SWP CROSS DRAINAGE EAST BRANCH Mile Post 303.9 to Mile Post 403.4 HYDROLOGIC & HYDRAULIC DATA TABLE B-5

STATE WATER FACILITIES
CALIFORNIA AQUEDUCT
MOJAVE DIVISION

CANAL STA. 1+64.10 TO STA. 955+91.27
STA. "P" 0+00 TO STA. "P" 29+00
TAPERED TRIPLE BOX CULVERT
STA. 151+40 PLAN AND SECTION
DRAINAGE PLAN STA. 143+00 TO STA. 175+00

Riverine Systems near SCH No. 20241000

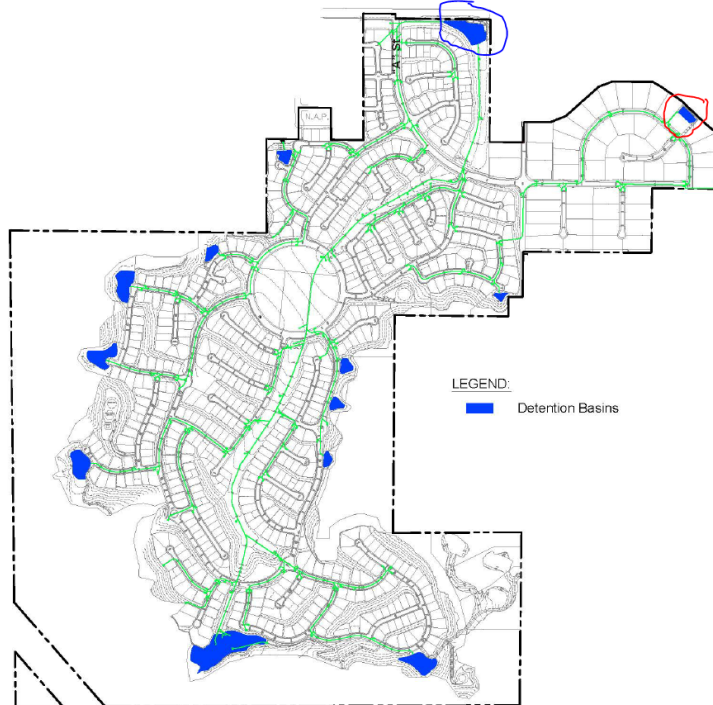
Blue = DWR Cross Drainage Structure MP344.8
(impacted by detention basin in Planning Area 1)

Red = DWR Cross Drainage Structure MP345.5
(impacted by detention basin in Planning Area 2)

TABLE B-5

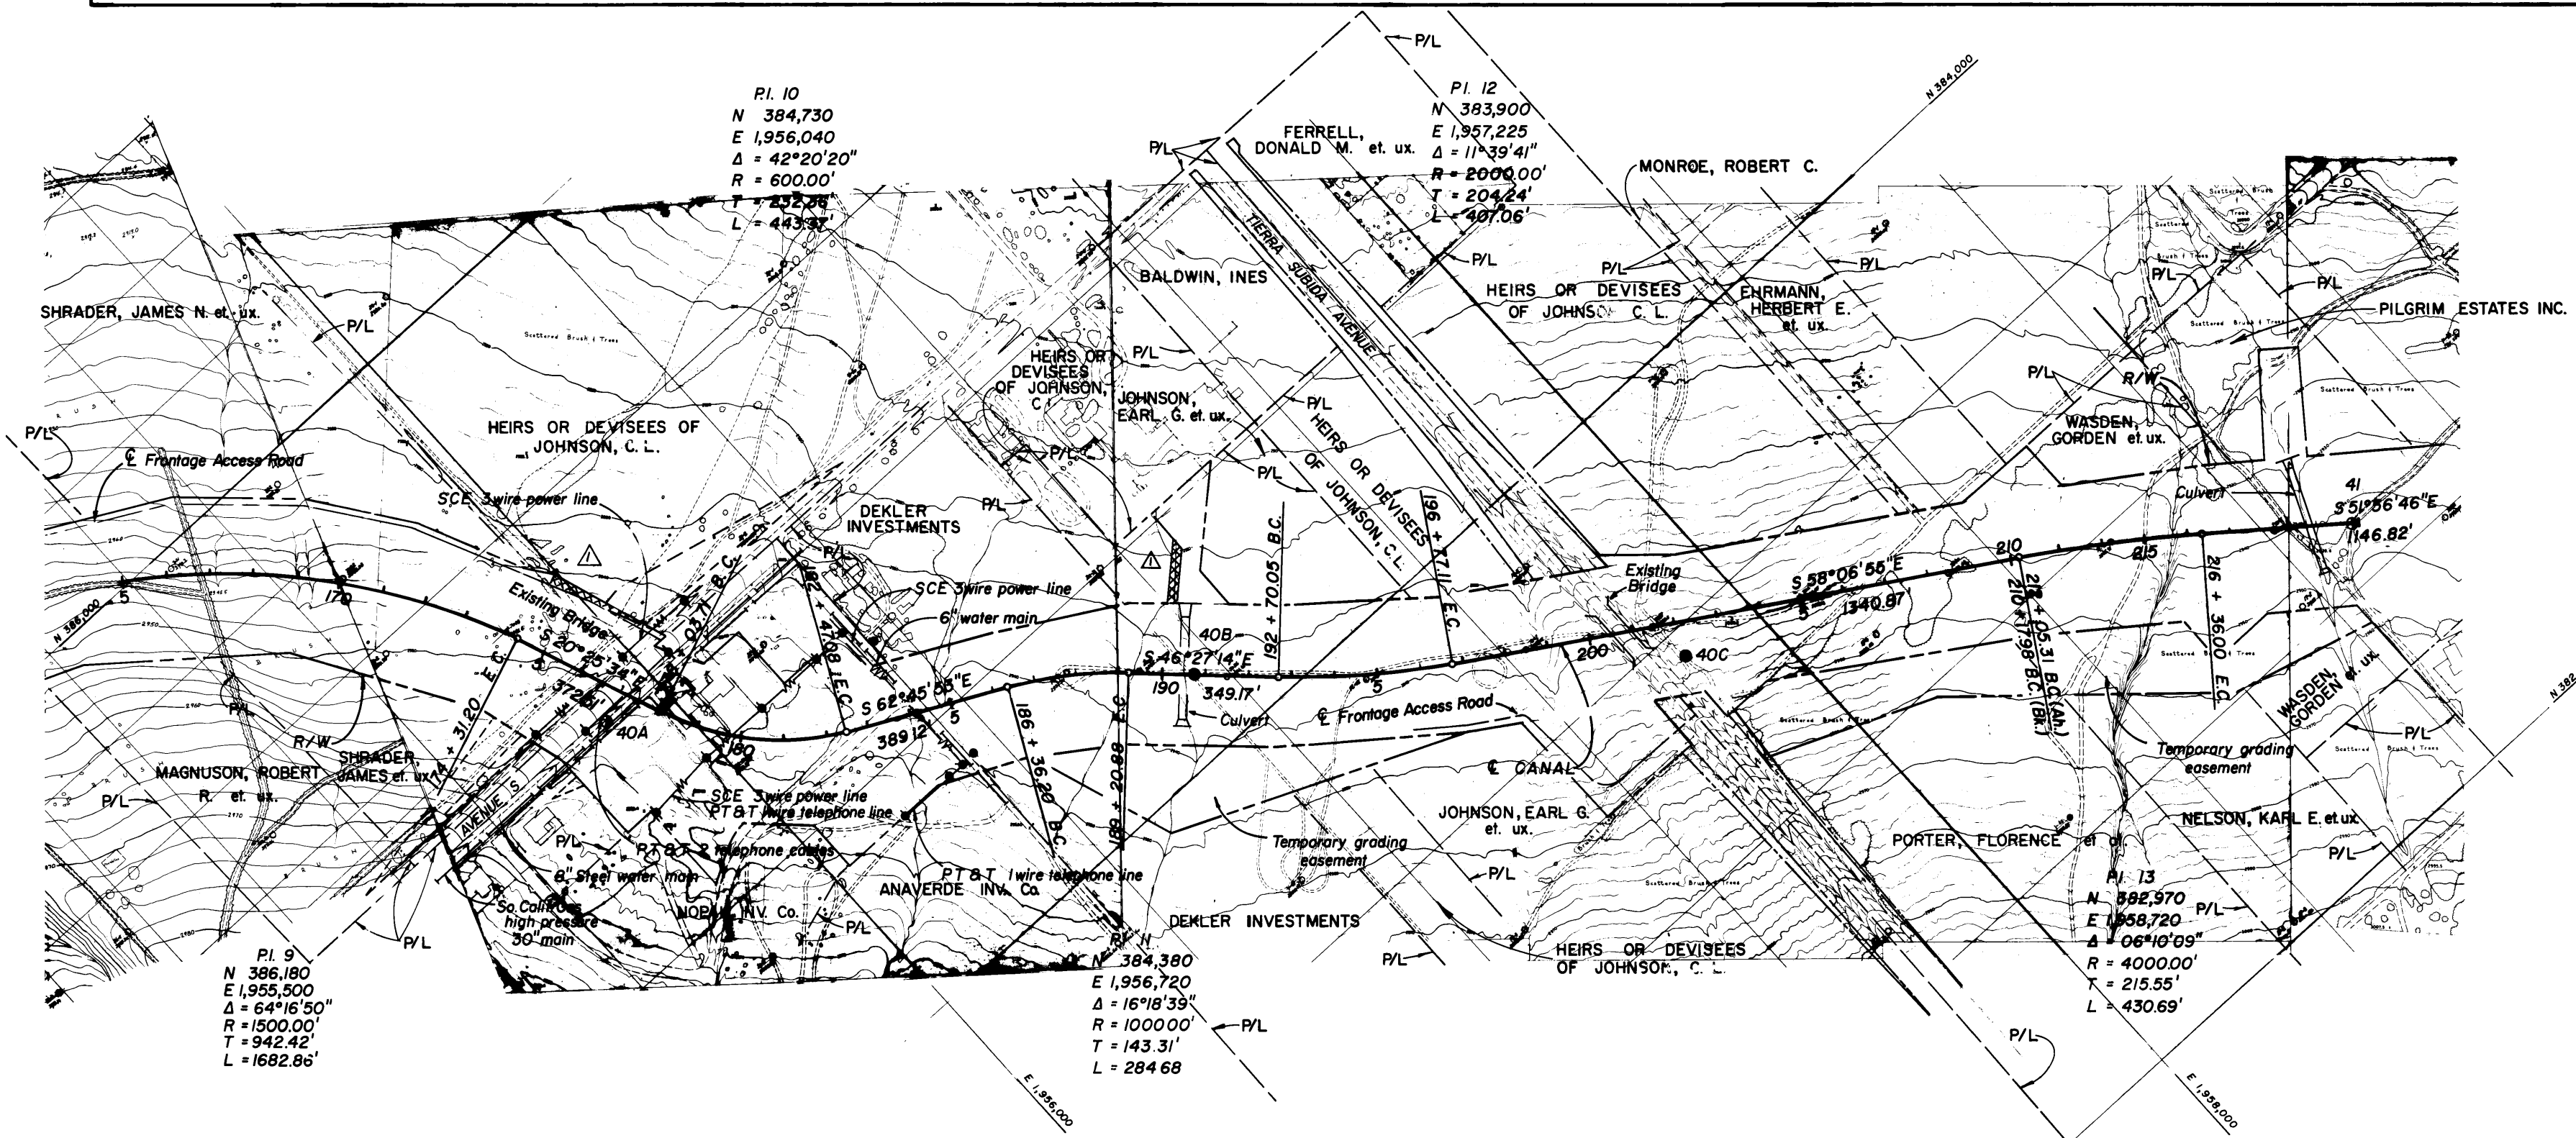
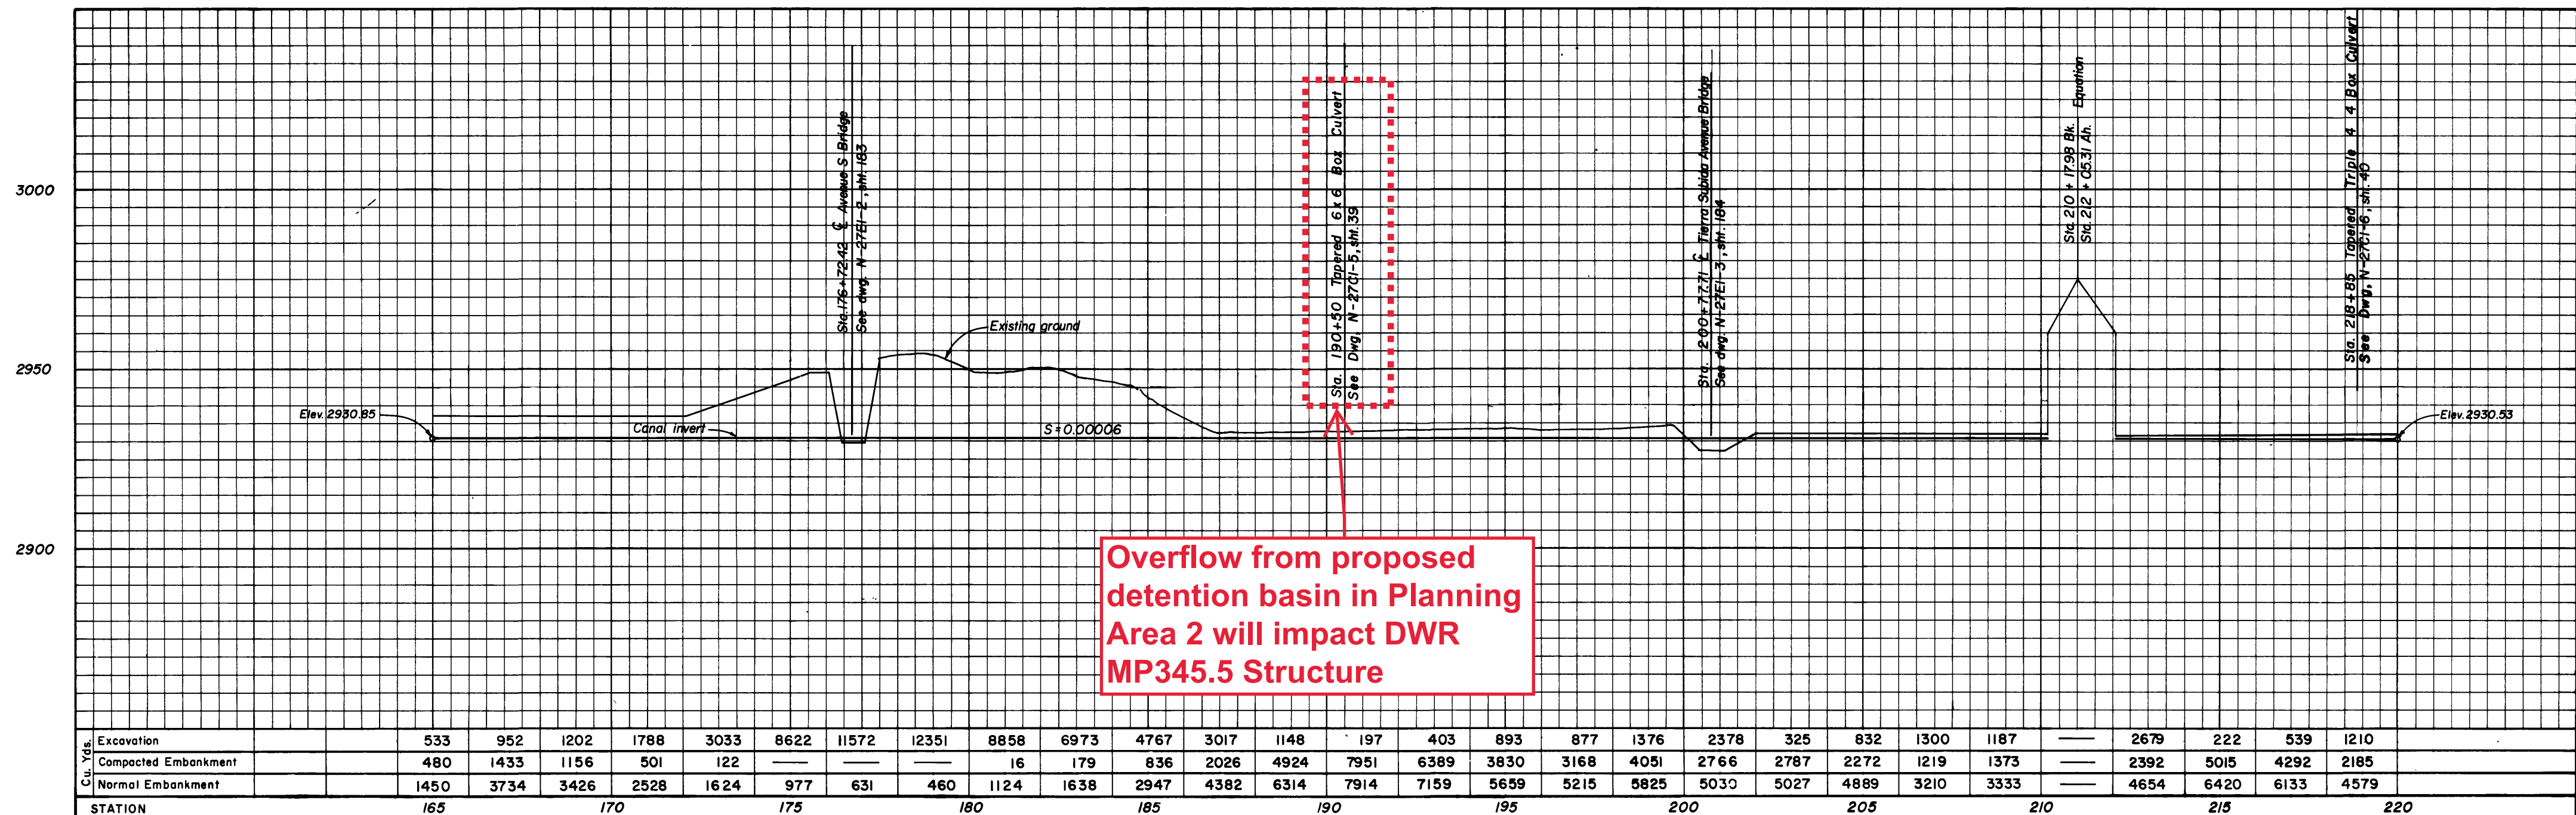
Overflow from proposed detention basin in Planning Area 1 circled in blue will impact DWR MP344.8 Structure

Overflow from proposed detention basin in Planning Area 2 circled in red will impact DWR MP345.5 Structure
